**SOILS ANALYSIS**  
 Existing soils on site include the following:  
 At - Atkins Silt loam  
 Erosion Hazard = Slight  
 Bc - Basher Silt loam  
 Erosion Hazard = Slight  
 LrB2, LrC2, LrD2 - Lewisberry gravelly sandy loam, 3-25%  
 Erosion Hazard = Moderate

**SURVEY LEGEND**

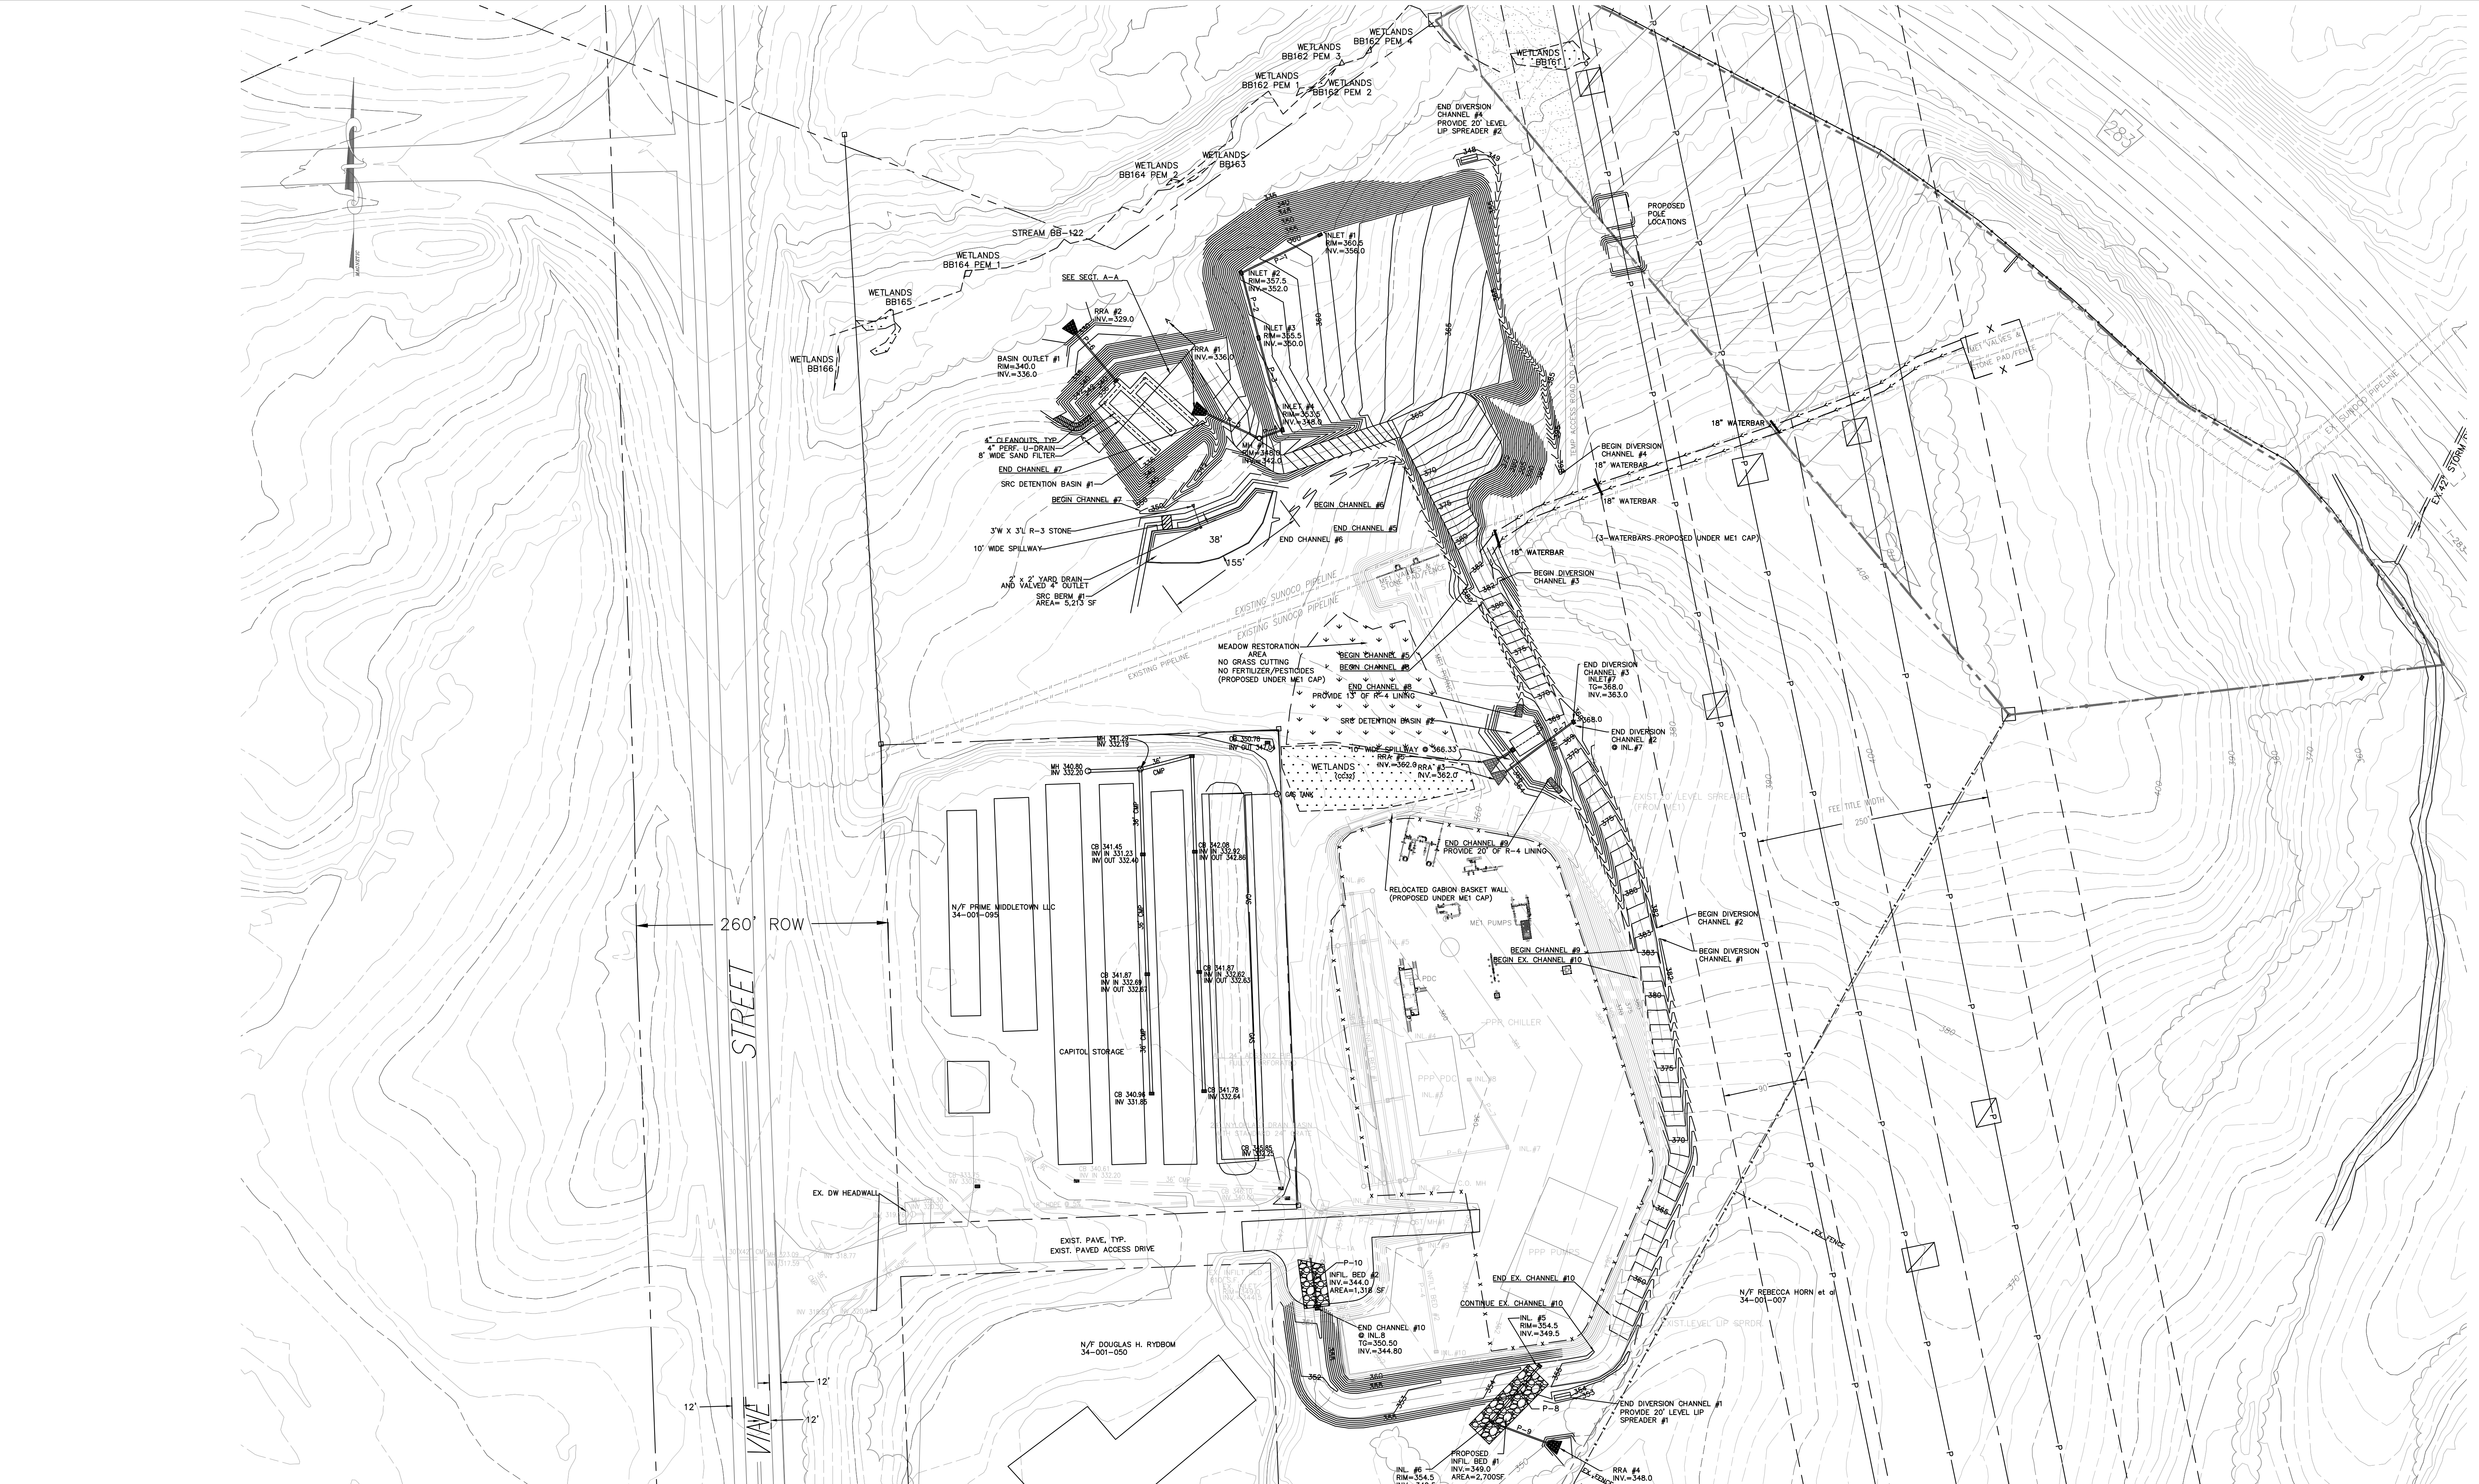
MARK	DATE	DESCRIPTION	BY
1.	4/22/16	REVISED PER EXISTING SURVEY	GZ
2.	4/26/16	REVISED PER HRG COMMENTS (4.14.16)	GZ
3.	10/27/16	REVISED PER DEP COMMENTS (9.6.16)	GZ

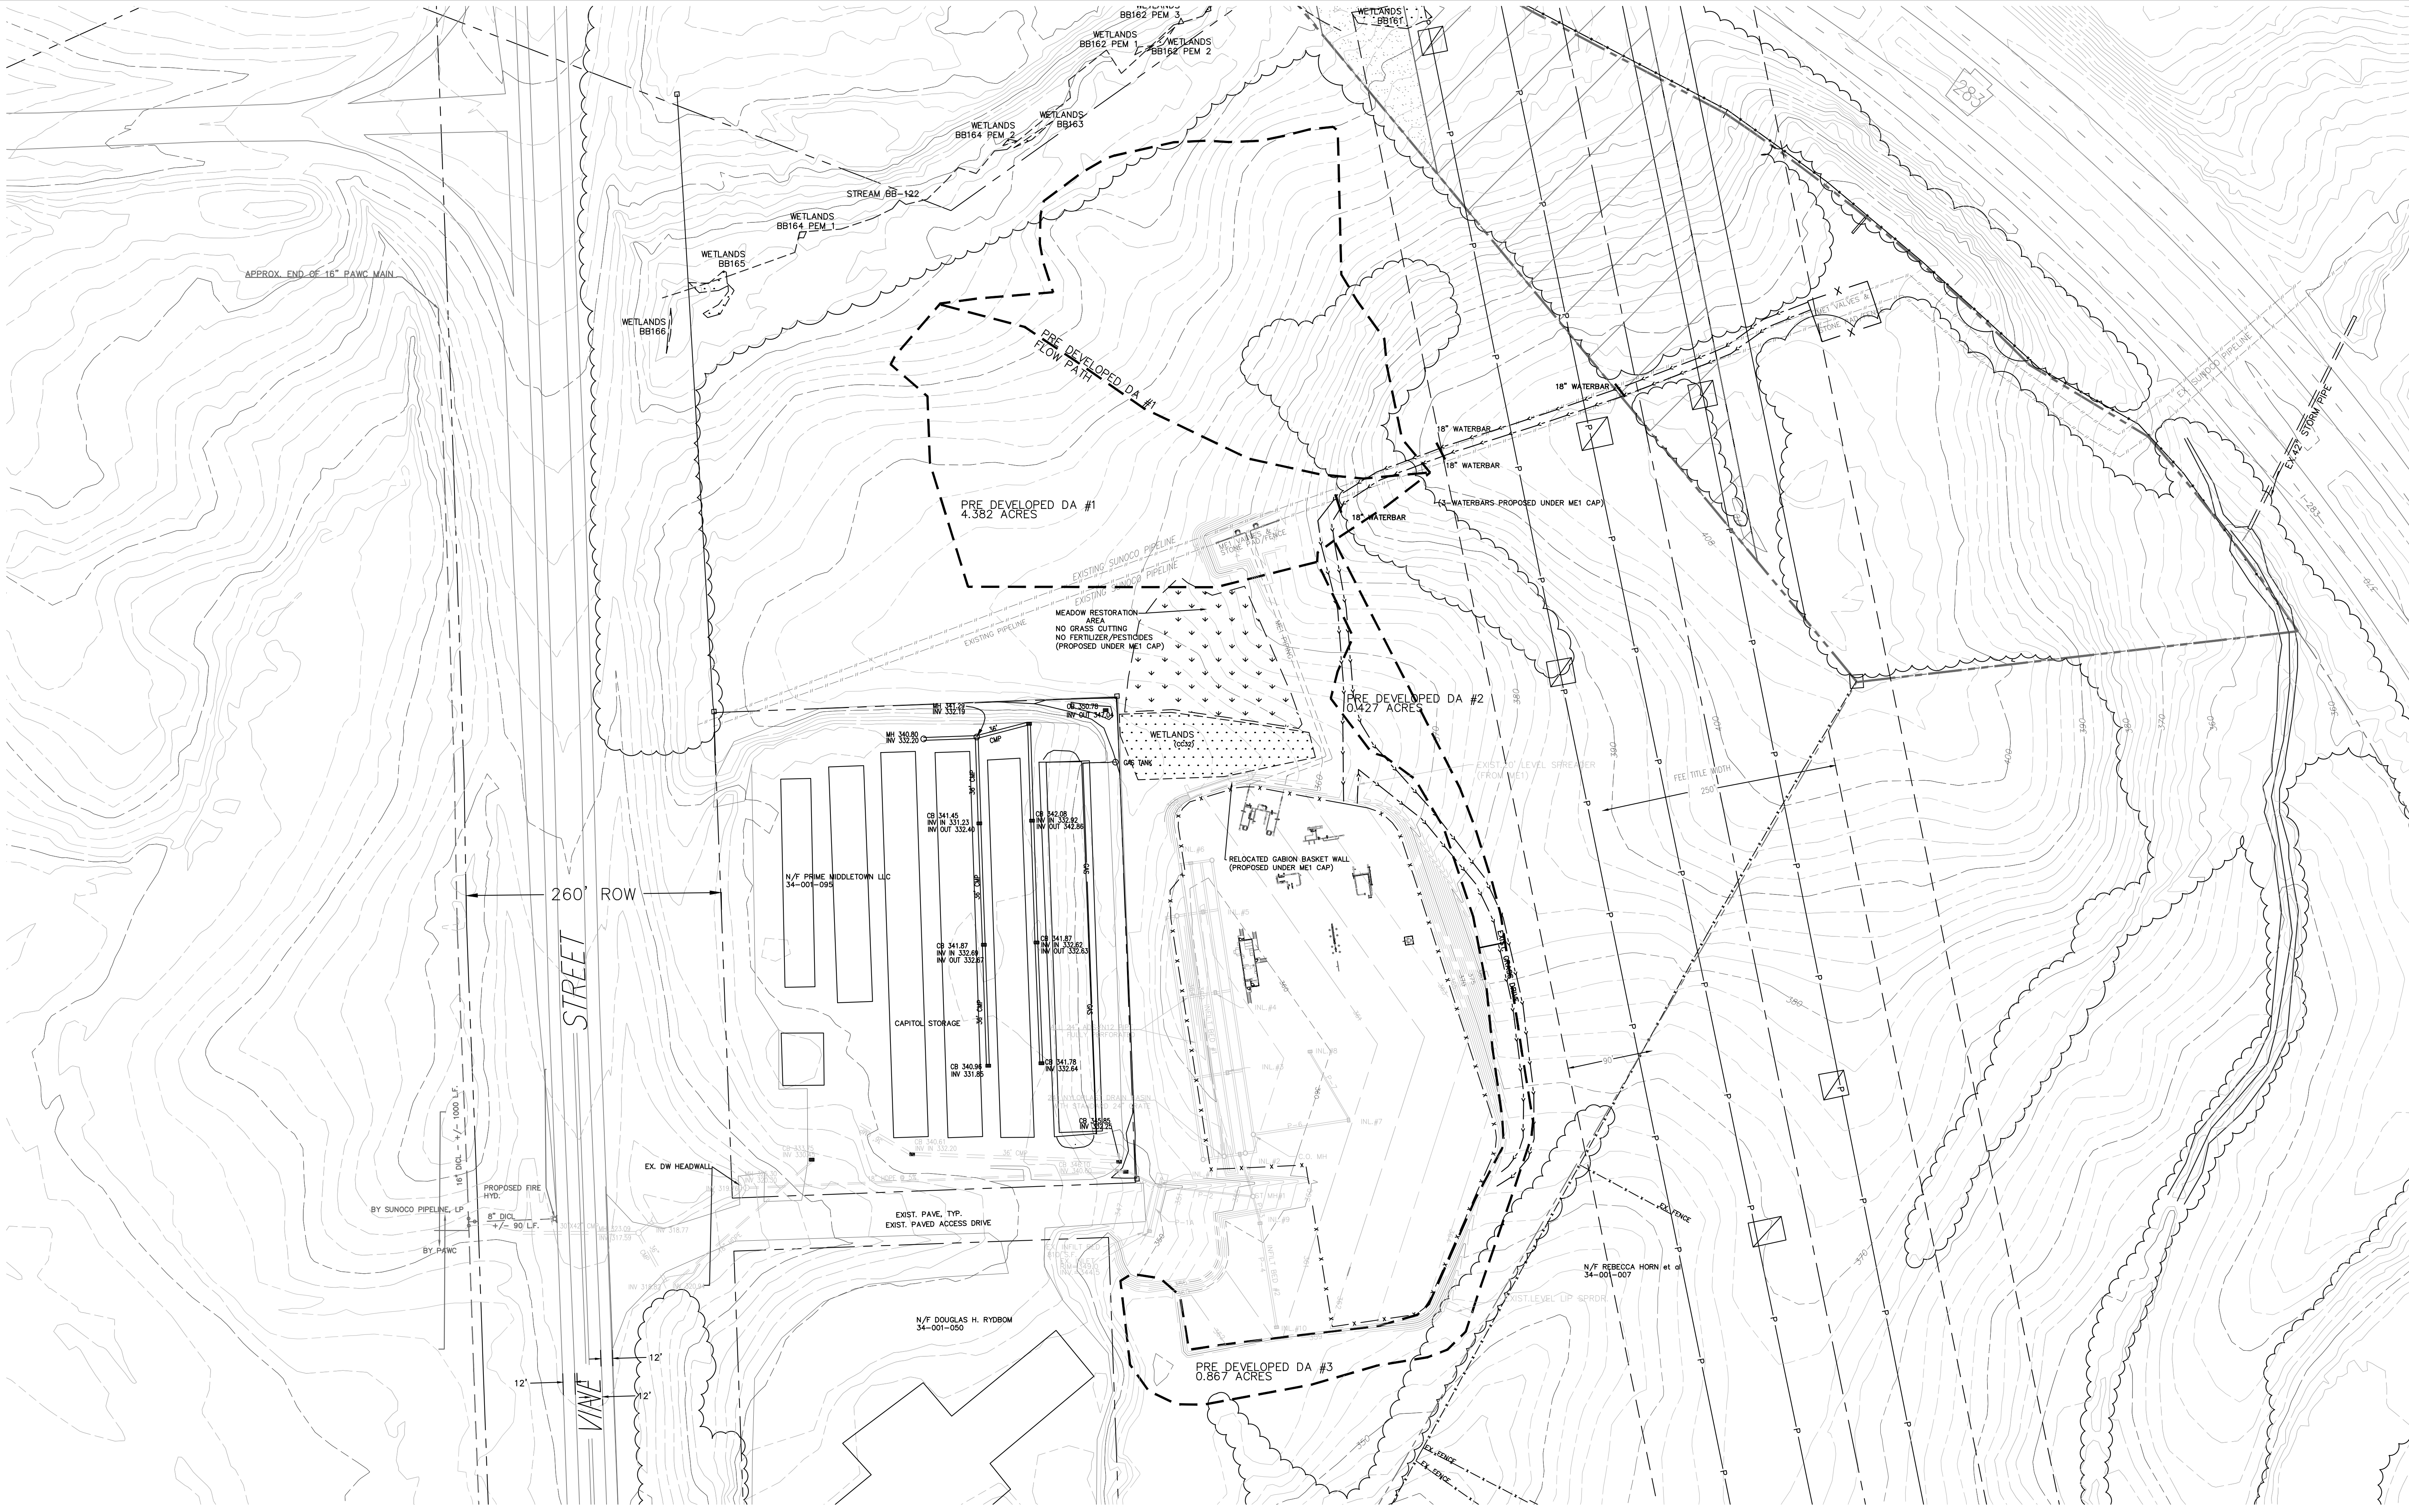
MARK	DATE	DESCRIPTION	BY
1.	4/22/16	REVISED PER EXISTING SURVEY	GZ
2.	4/26/16	REVISED PER HRG COMMENTS (4.14.16)	GZ
3.	10/27/16	REVISED PER DEP COMMENTS (9.6.16)	GZ

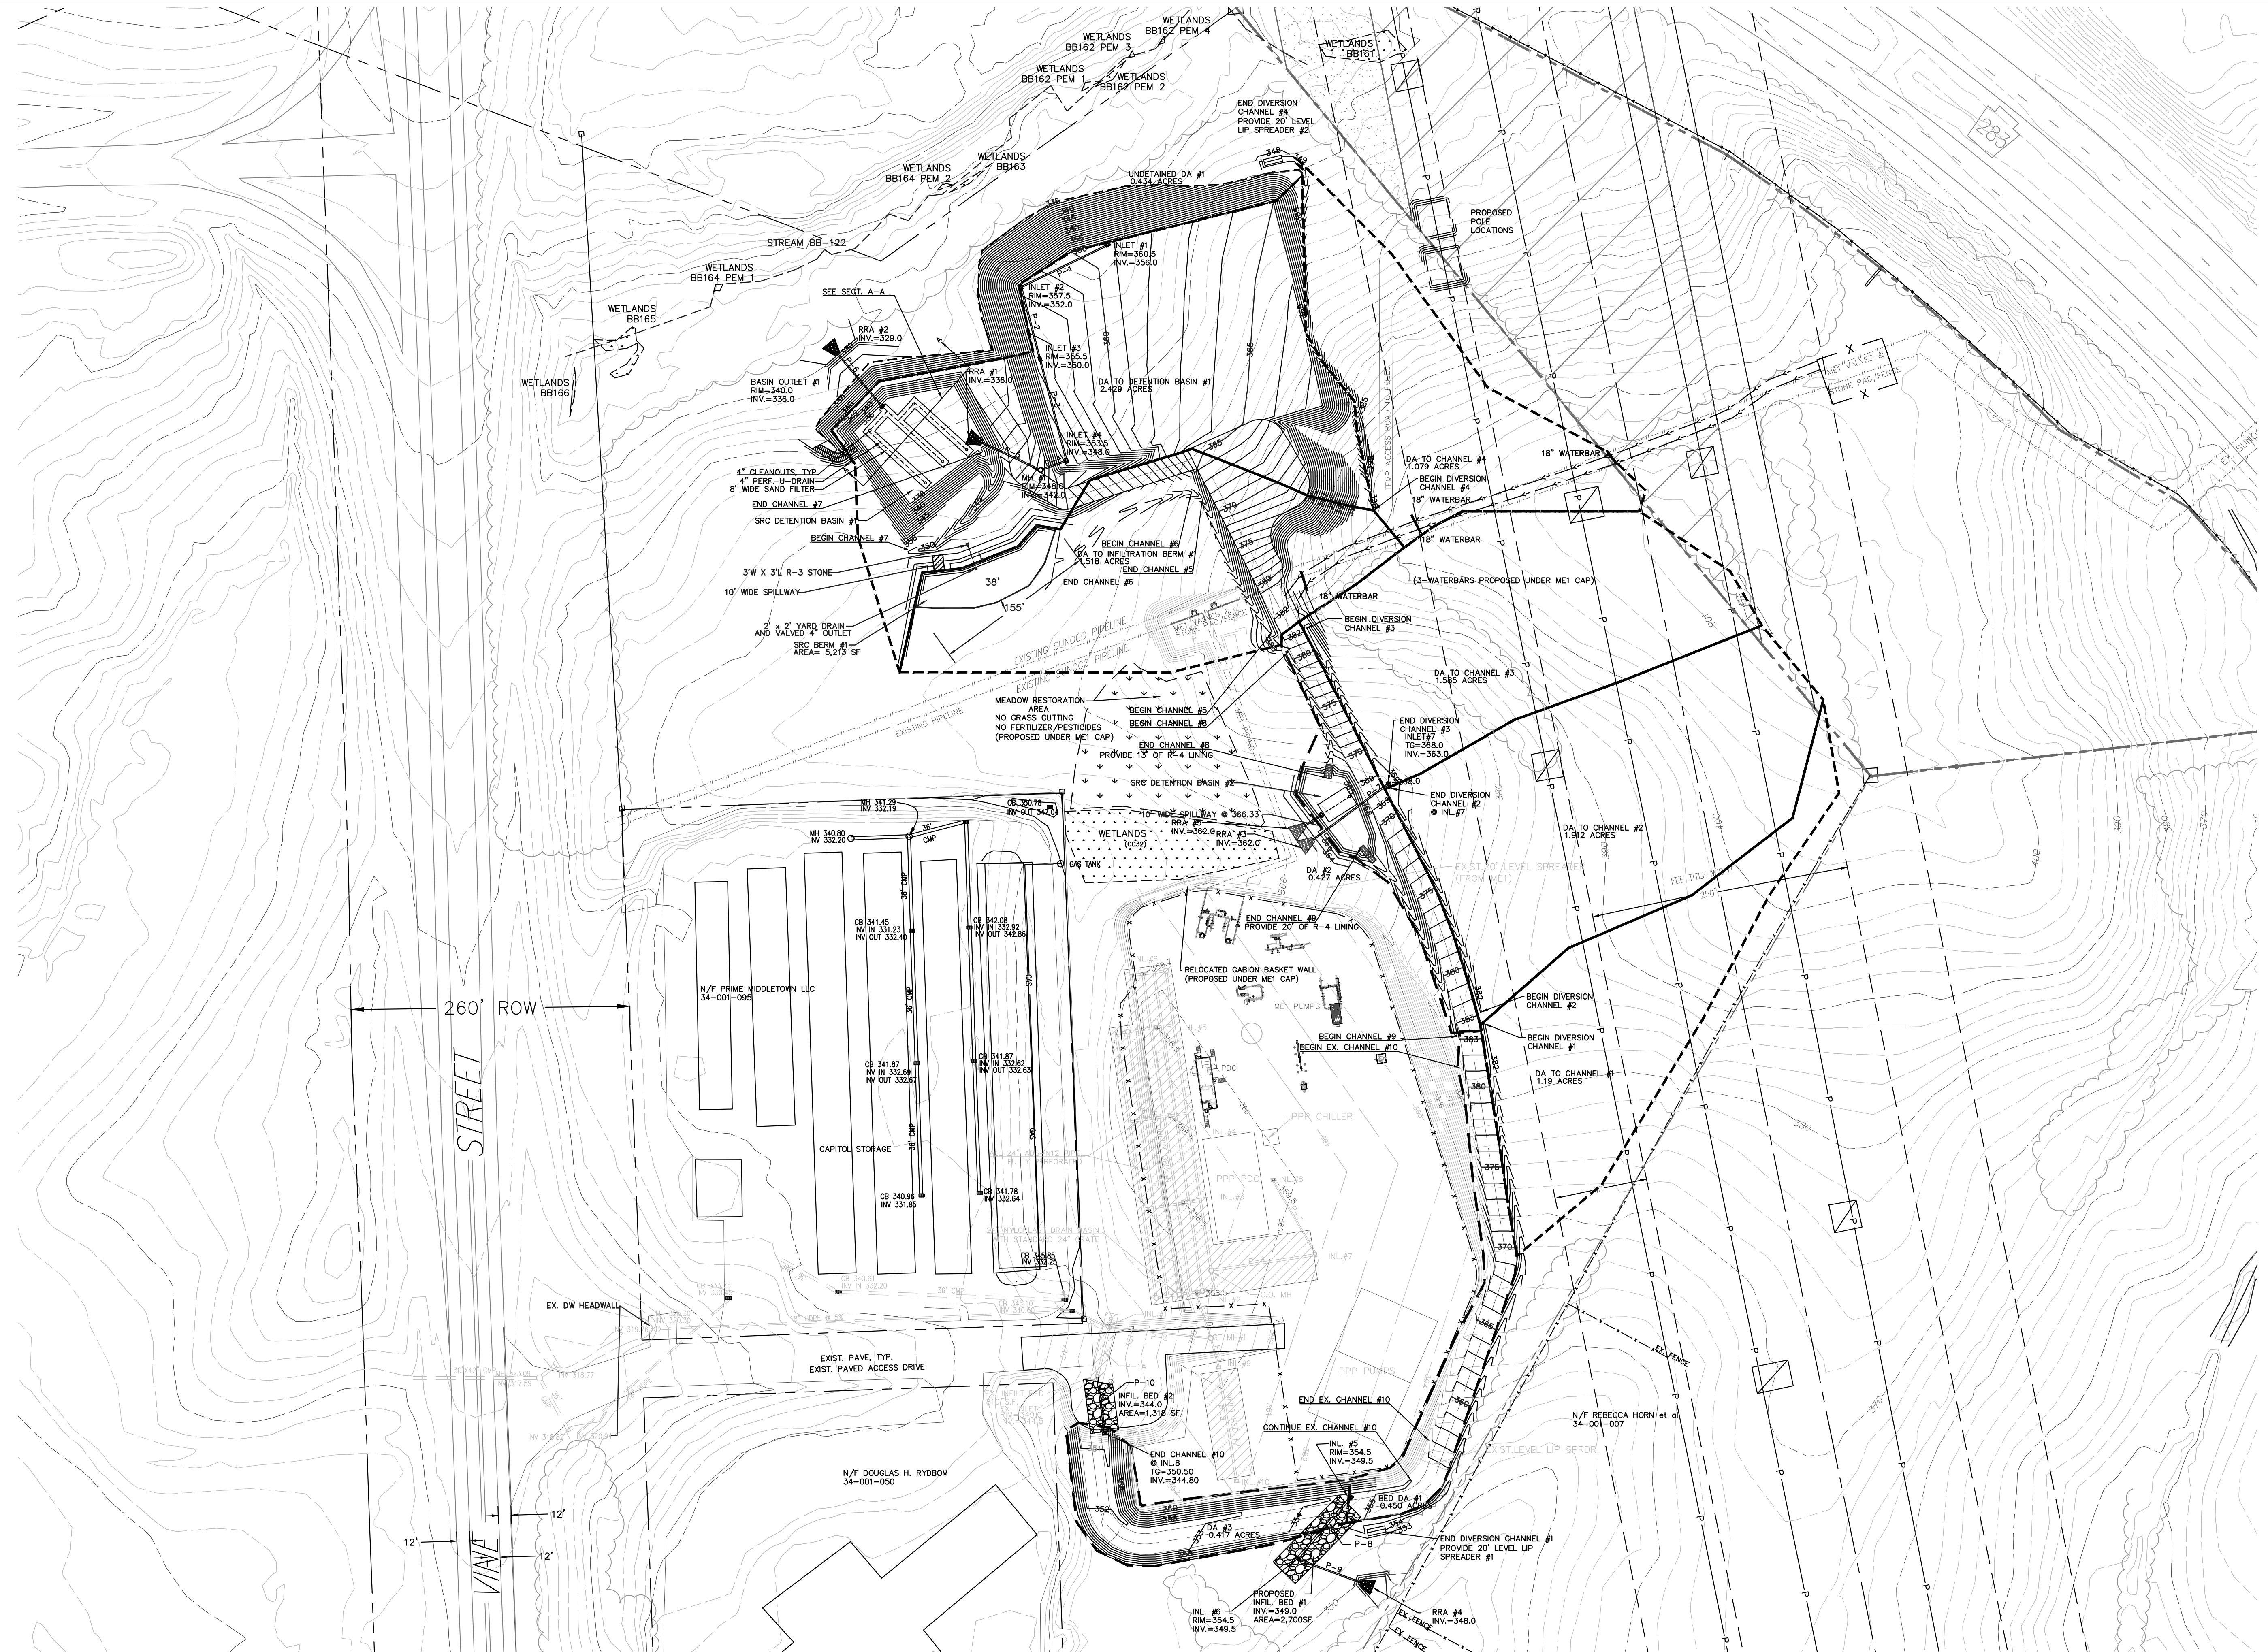
MARK	DATE	DESCRIPTION	BY
1.	4/22/16	REVISED PER EXISTING SURVEY	GZ
2.	4/26/16	REVISED PER HRG COMMENTS (4.14.16)	GZ
3.	10/27/16	REVISED PER DEP COMMENTS (9.6.16)	GZ
